BROOKHAVEN NATIONAL LABORATORY

MEMORANDUM

Date: 11/17/89
To: E. Lessard
From: J. Alessi *g.a.*
Subject: Review of the Linac security system

Following your memo dated April 20, 1989, the ad hoc committee of P. Montemurro, B. Briscoe, D. Pope, and myself (Chairman) met eight times to review the logic of the design of the security system for High Hazard Radiation Areas in the Linac, HEBT, BLIP, and REF/NBTF. We also compared the design to existing hardware. REF/NBTF was reviewed only at the point where it ties in to the Linac security system, and the Linac system only serves as a reachback in case of a failure of the REF primary or redundant system. Their system is otherwise independent, and had been recently reviewed since it is a new installation. *removed*

BROOKHAVEN NATIONAL LABORATORY			
UTRON, N.Y. 11972			
Title: APPROVED LINAC SECURITY LOGIC			
Doc#	Document Number	A.J. McGeary	REV
0	LINLOG		0
Date:	July 20, 1982	Sheet	of 1

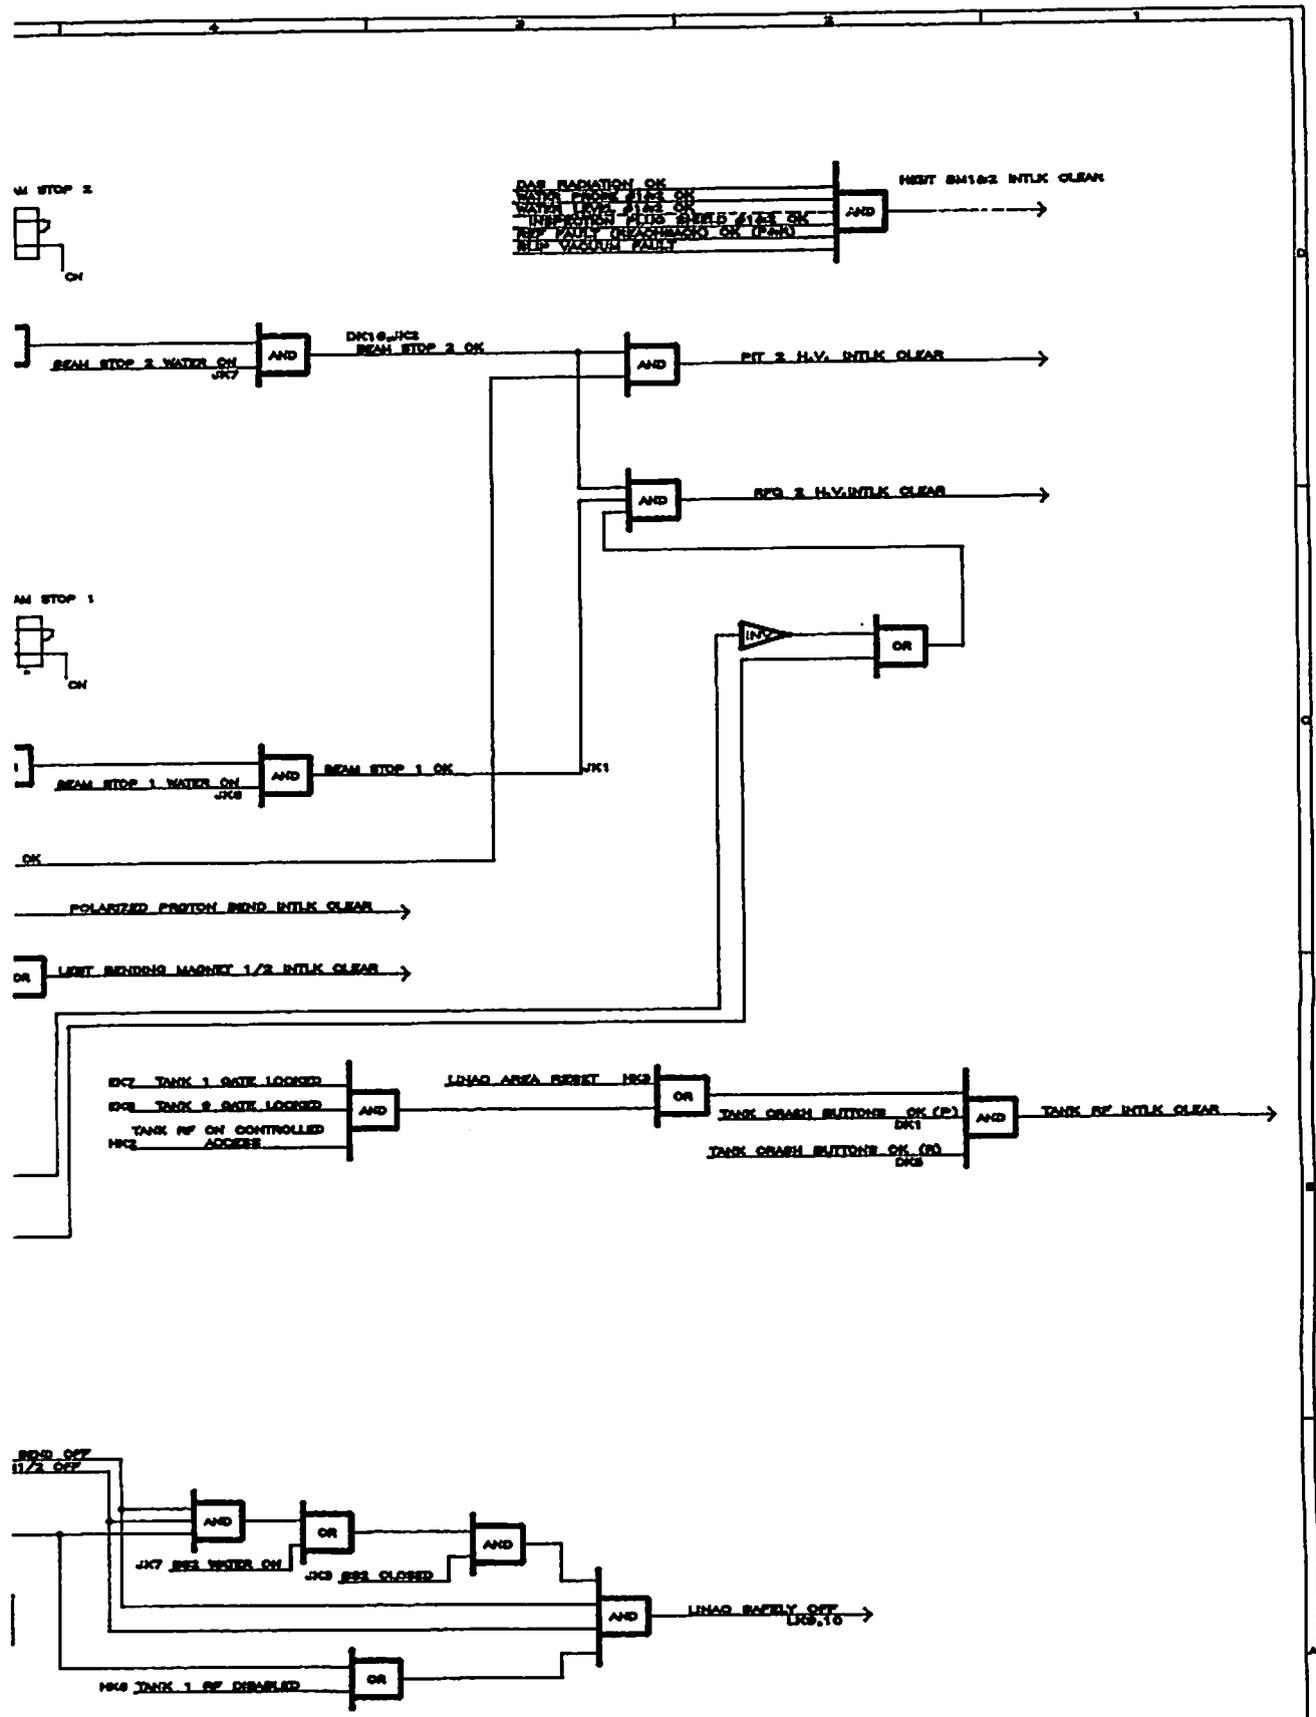
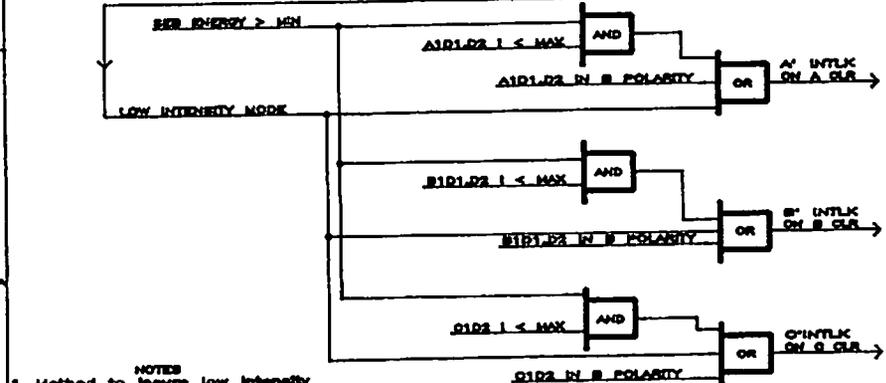
1. The polarized bending magnet (action 6 in Appendix 4) is not included in the reachback circuits for Beam Stop 2 failure (E.7. and E.8.) or LBM1 failure (E.13.).

2. There is a portion of the relay logic for the gates and crash buttons which is not redundant. All inputs are redundant, and two independent actions occur in each case to inhibit the beam. However, the primary and redundant system relays are placed in series to activate relays A21HK7 and A21HK8 on drawing D09-E1776. A single-point failure could occur if a voltage were inadvertently applied at this location.

3. We found no discrepancies between the logic diagram and the wiring diagrams. The logic diagram does not fully show the redundancy of the system, but including the redundancy would complicate the diagram to the point that it would be difficult to follow the functionality. Other than the items above, the system seems to perform as it should. There are a couple of minor changes which could be made in the logic, unrelated to High Hazard Safety but rather regarding some conditions to allow equipment testing when the Linac is off. The committee will present these to A. McGeary for future consideration.

1. We recommend that the polarized bending magnet be added to the reachbacks for Beam Stop 2 and LBM1. This should be corrected before polarized H⁻ is run again (not scheduled for FY90).

2. We recommend that the non-redundant portion of the relay logic, described in Finding 2, be changed so that the primary and redundant systems are kept separate throughout the relay logic. However, since this is an extremely unlikely failure mode (the point is inside a locked security cabinet), we recommend that the change not be made before the AGS is turned back on, but rather that it be made at a future time (a maintenance day, for example). This change is occurring at a critical location in the security logic, and its implementation should not be rushed, but rather the proper solution should be addressed carefully, and then fully tested.
